WASHINGTON COUNTY PLANNING COMMISSION
REGULAR MEETING
January 9, 2017, 7:00 PM
WASHINGTON COUNTY ADMINISTRATION BUILDING
100 WEST WASHINGTON STREET
2ND FLOOR, ROOM 255

RE: Preliminary Consultation
PC-16-001 – Pharmacy/Drugstore – Jefferson Blvd.

**PRELIMINARY CONSULTATION
PC-16-001 – PHARMACY – DRUGSTORE – JEFFERSON BLVD.**

Re: Pharmacy / Drug Store – Jefferson Blvd (PC-16-001)

PHARMACY CONCEPT PLAN
 SHEET 1 OF 1
 C-101

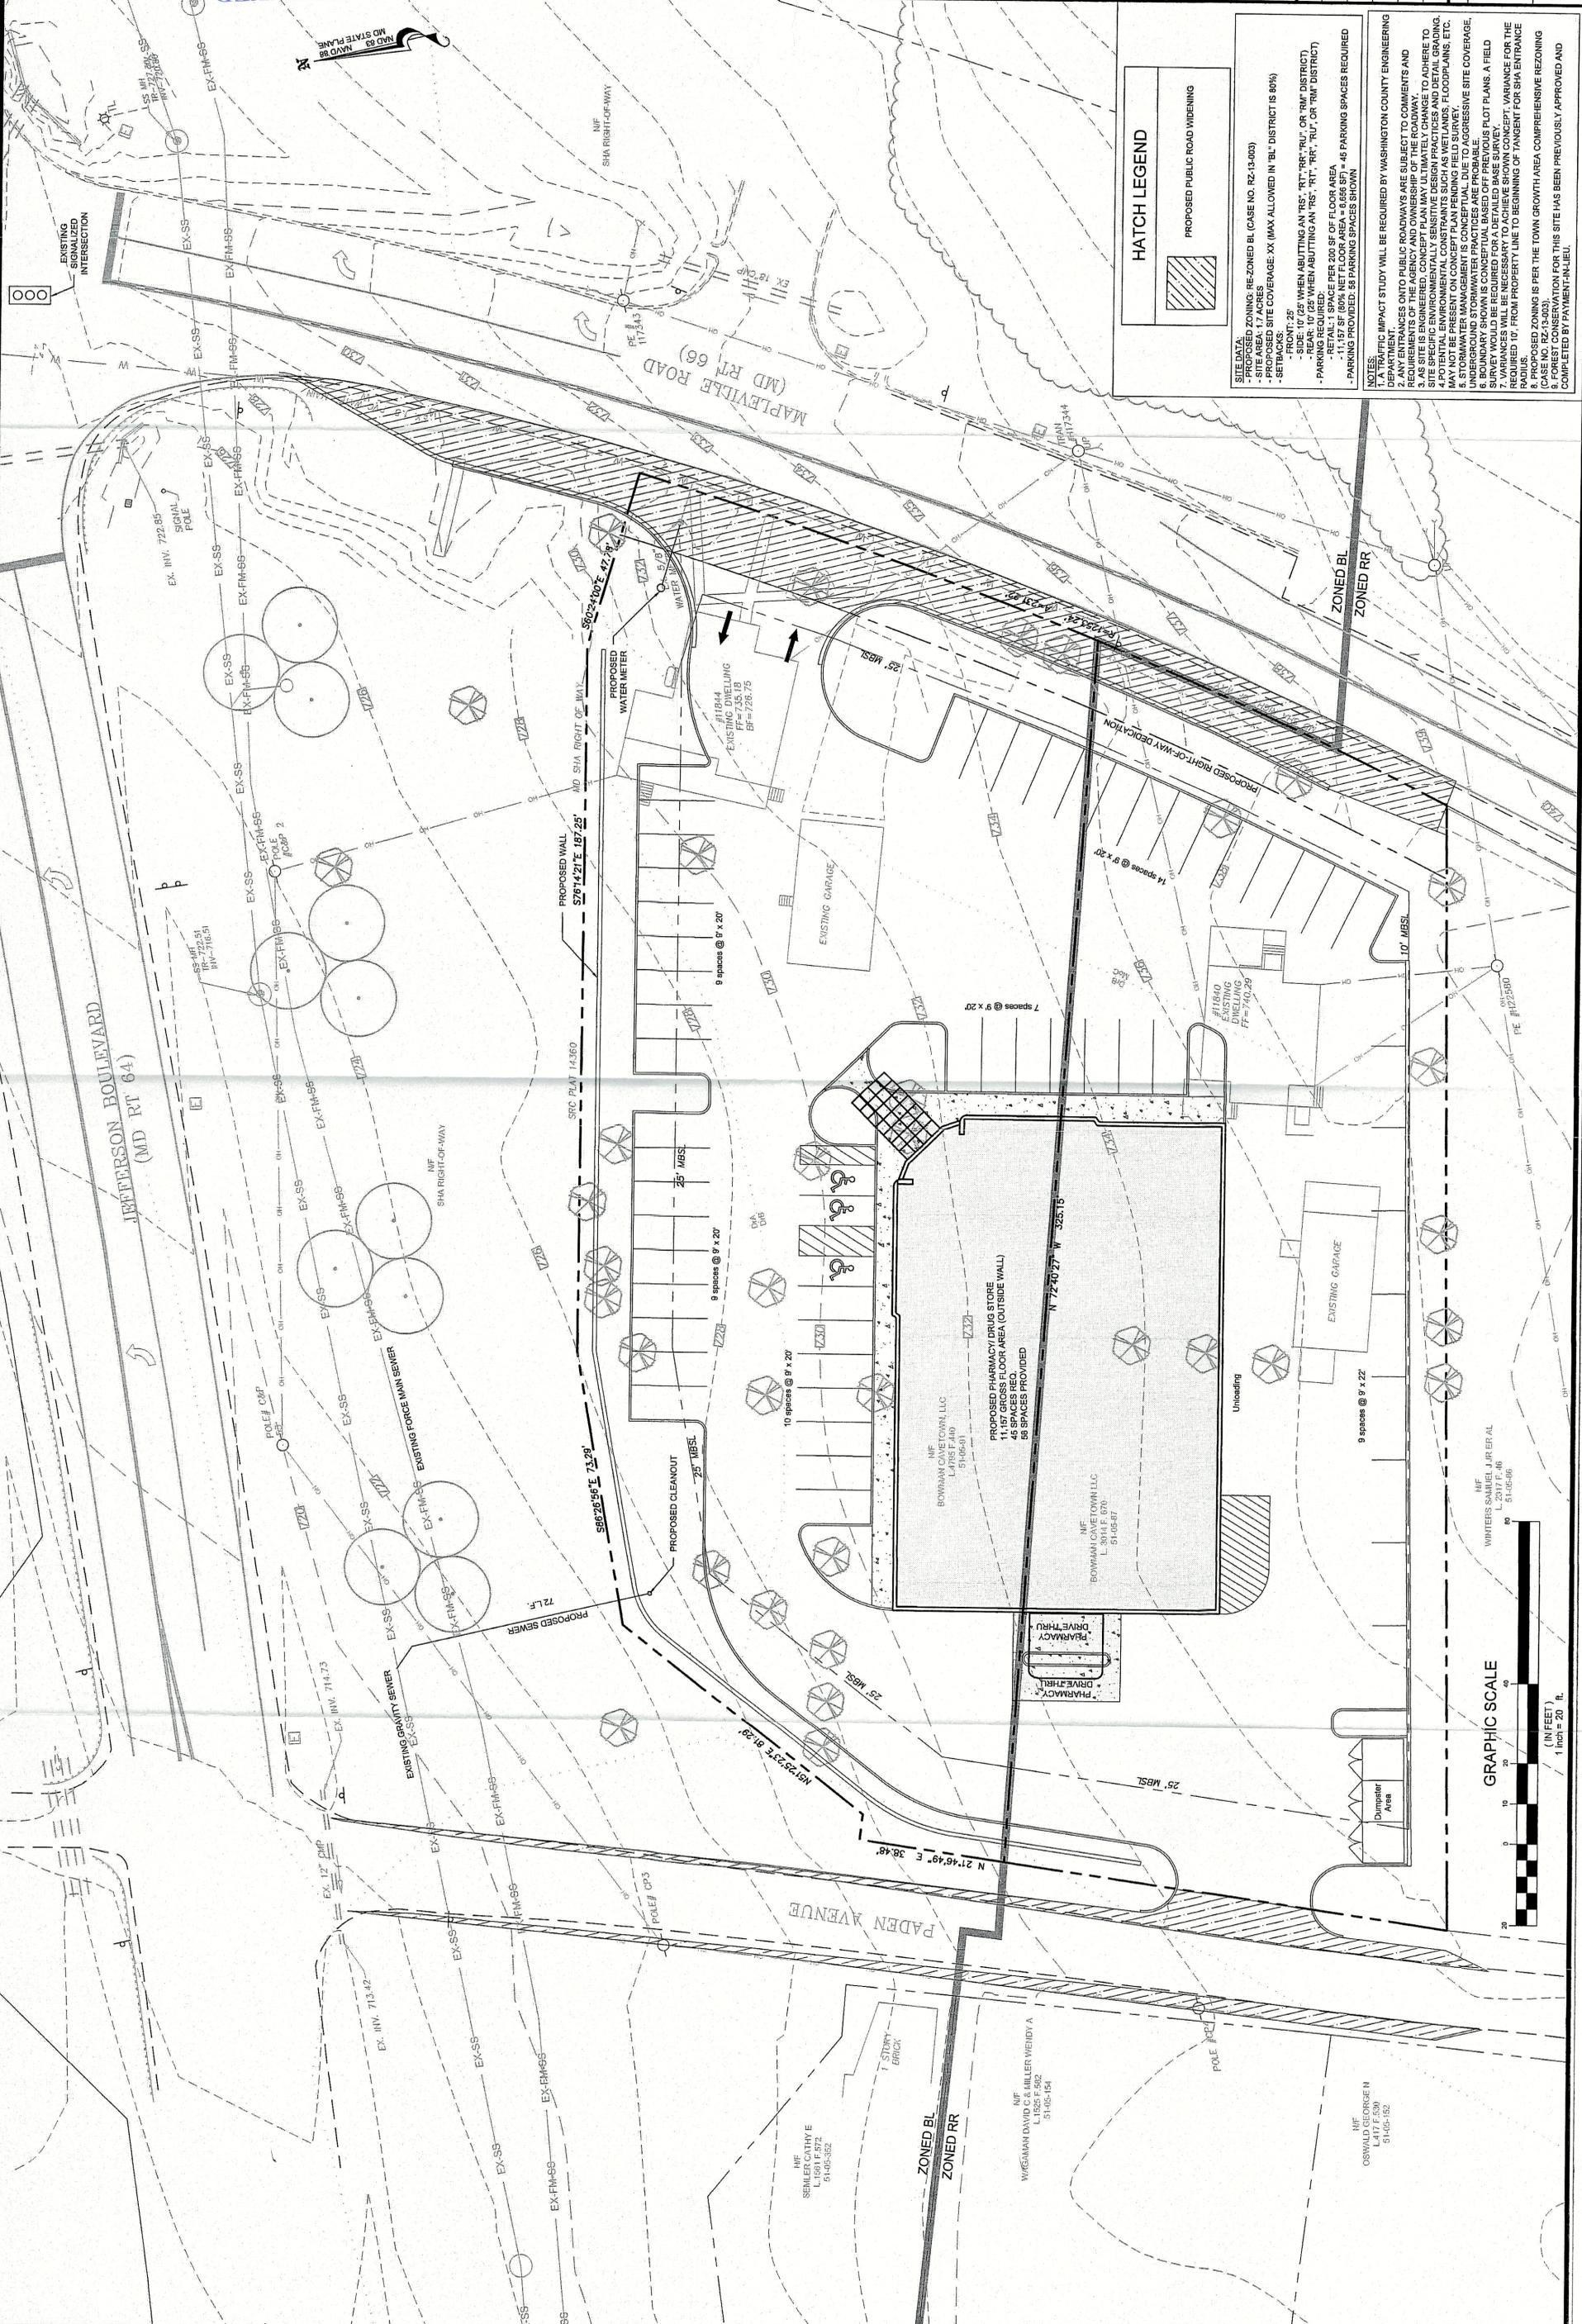
1. ITE (881) predicts peak hour trips of 38 (AM) and 111 (PM). A Traffic Impact Study will be required.
2. MD 66 is classified as a Major Collector in the County's Comprehensive Plan. County standards require 300' between access points. 190' is shown on the Concept plan. However, it does appear that sight distance could be an issue if the driveway is moved to the south to increase access spacing.

3. SHA will need to approve the proposed main driveway entrance and any entrance improvements on MD 66.
4. Sight distance needs to be verified for all access driveways.

5. County commercial driveway standards will be required for Paden Avenue access.
6. Paden Avenue is inadequate in both width and the MD 66/Paden Avenue intersection and will require mitigation.

7. Previous meetings between the County and the developer for this site discussed layout changes to Paden Avenue (cul-de-sac or intersection re-alignment with MD 66). What is the status of these plans with this project?

8. The County will not support a major commercial development on this parcel without an improvement to the MD 66/Paden Avenue intersection.
9. The developer is encouraged to approach and begin working with affected neighbors as soon as possible regarding any changes to Paden Avenue.

10. The developer will be required to take the lead in advocating for and implementing changes to Paden Avenue.
11. If the cul-de-sac improvement option is chosen, several items should be noted;

- a. This option would involve vacating County ROW. This process will involve the County Commissioners. The County recommends that a public meeting be conducted to allow any issues with this option to be discussed and resolved.
- b. The County will not advocate for this option, however the County does not necessarily object as long as any issues involving any affected neighbors are adequately addressed.

12. No SWM is shown or considered on the Concept Plan.
13. Are there any sensitive areas on the site?
14. Storm water drains towards SHA ROW. SHA H&H review may be required.
15. SW quantity management may be an issue (12" pipe). What storm will SHA require management?
16. The County encourages above ground SWM. Justification for underground SWM will be required.
17. Could any pavement be reduced to provide room for SWM?

18. Good drainage will be required for the wall since it is located at the low end of the site.

SITE PLAN
EMERALD POINTE P.U.D.
COMMERCIAL AREA
SITUATE AT THE INTERSECTION OF MD RT. 60, MARSH PIKE
WASHINGTON COUNTY, MARYLAND
ELECTION DISTRICT 18 (CHEWVILLE)

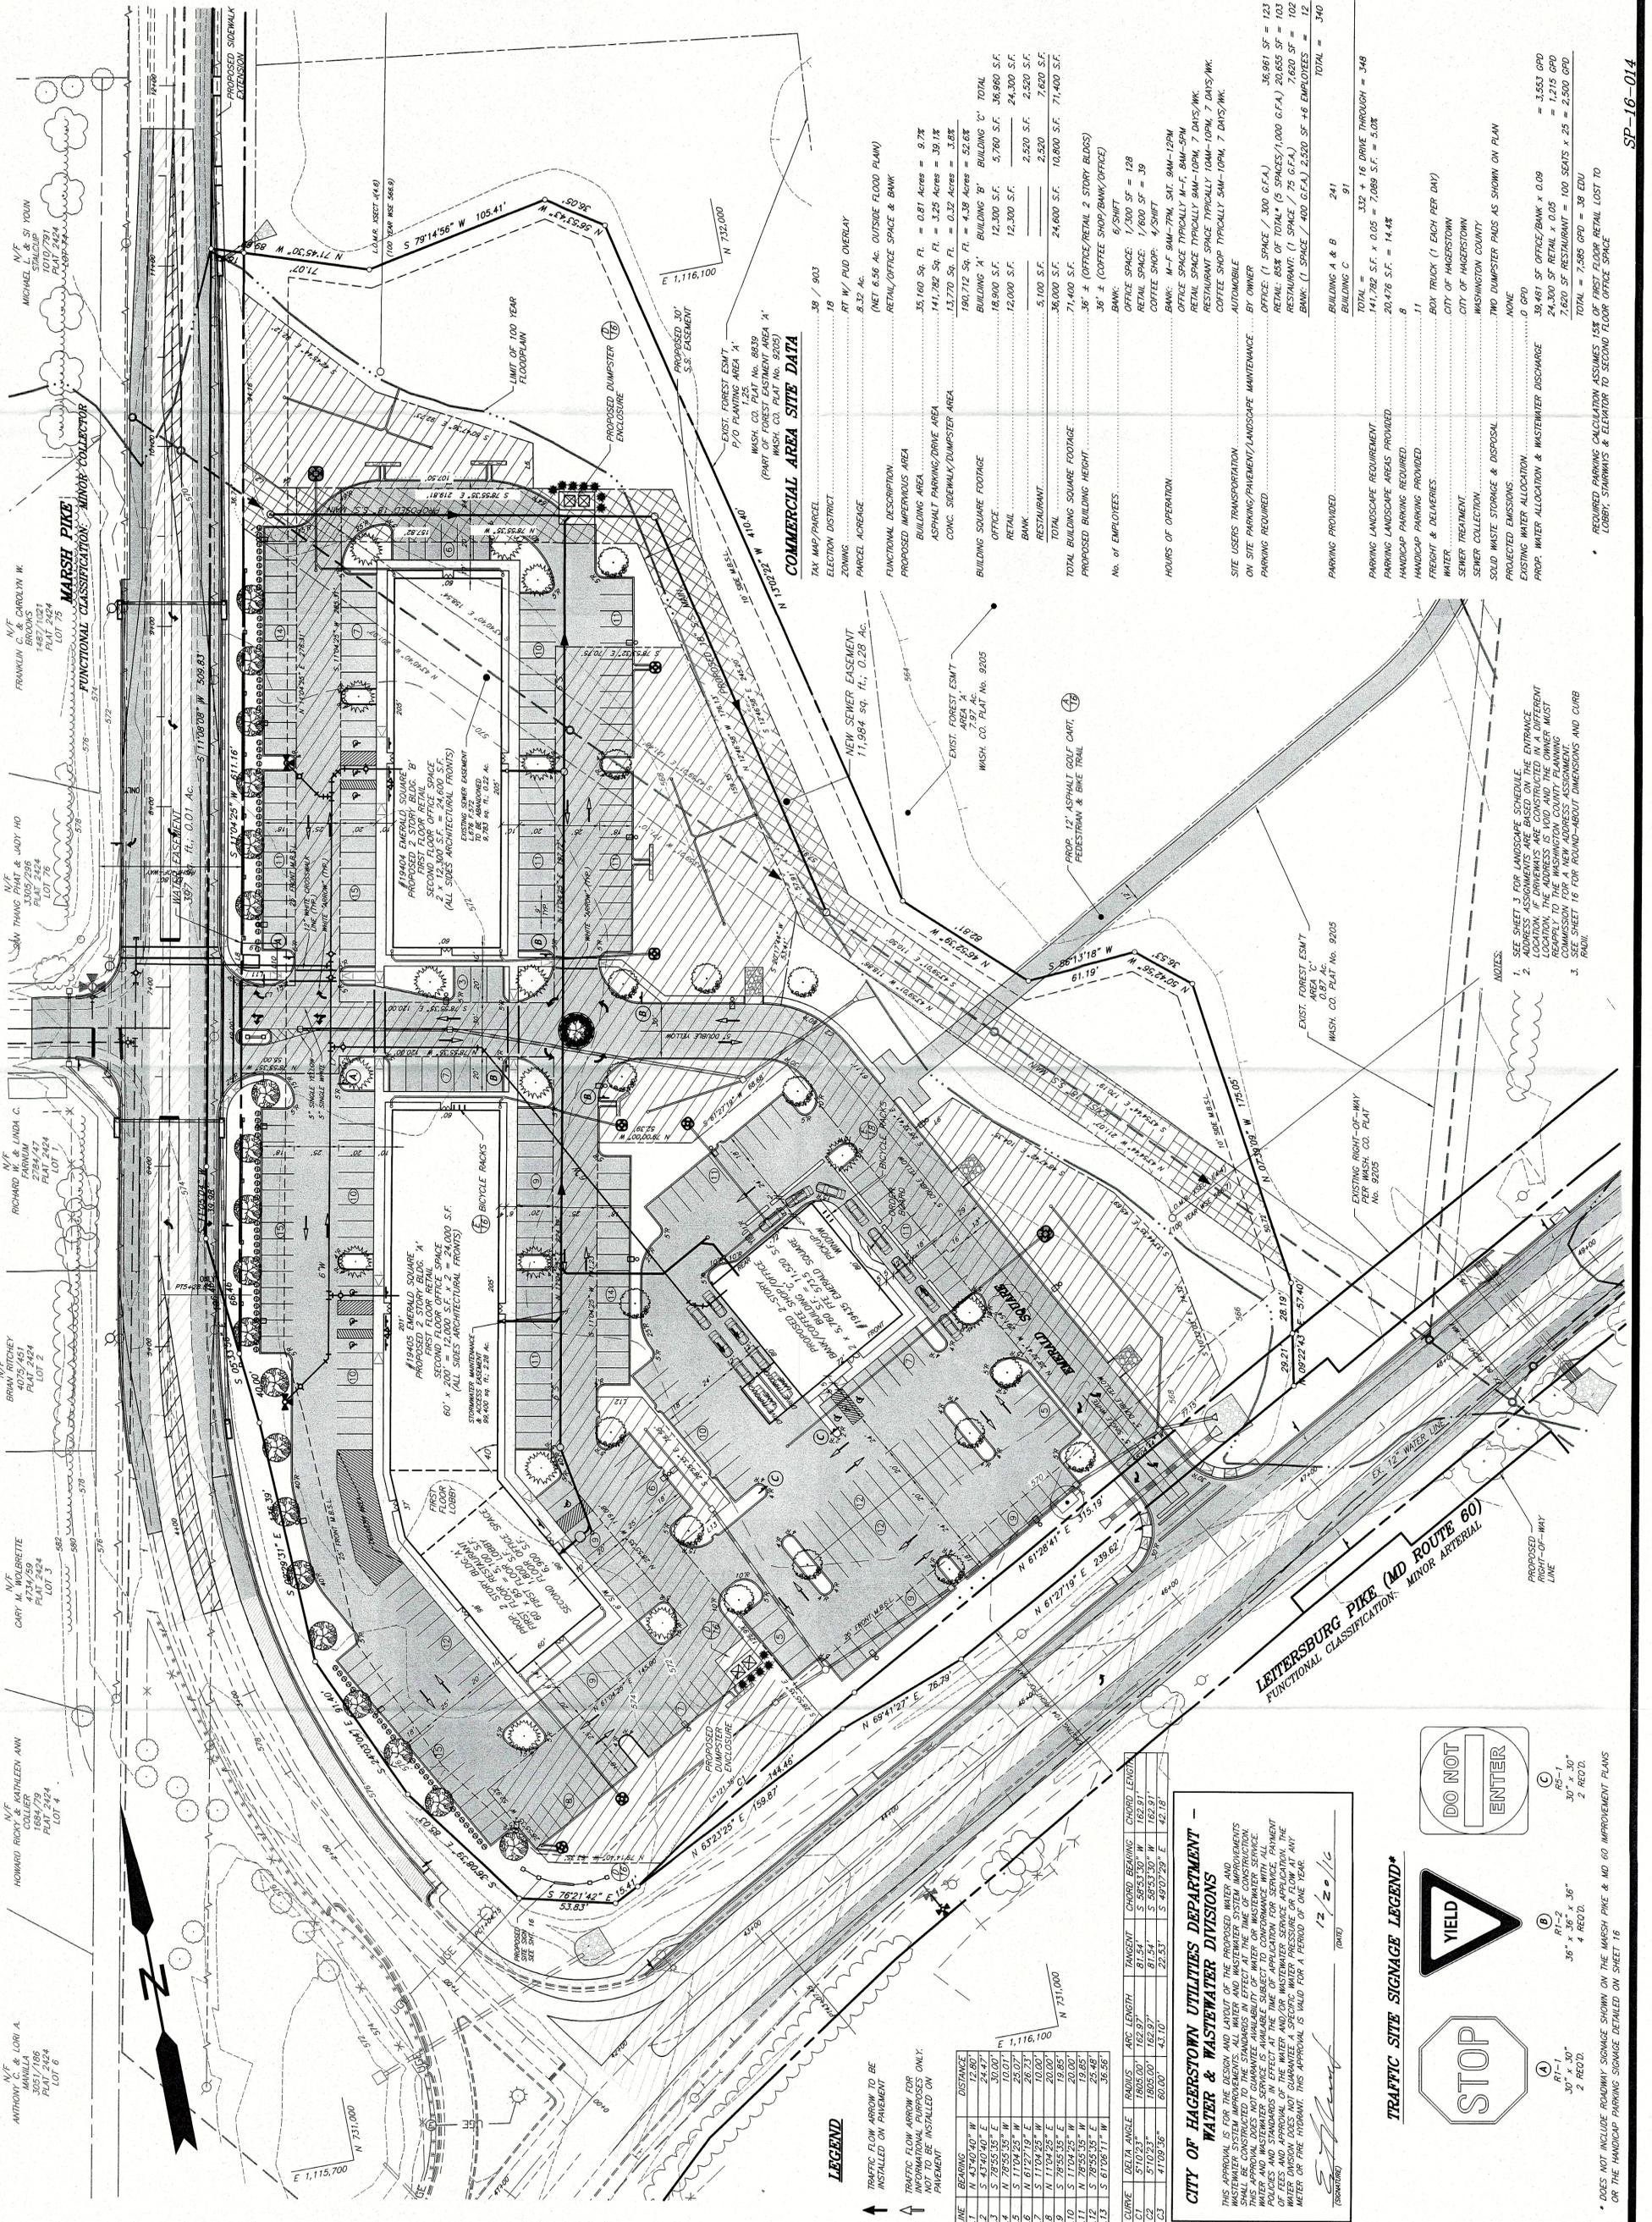
1. A reversal from the first review, the MSHA is requesting thermoplastic pavement markings.
2. MSHA is requesting a Sidewalk Maintenance Agreement since the sidewalk will be located within the MSHA right-of-way.
3. Obtain MDE permit. An application for this permit has been submitted.
4. Revise SWM to treat SHA runoff in the SHA right-of-way.
5. Revise previously submitted hydraulic model to existing MD60 culverts.
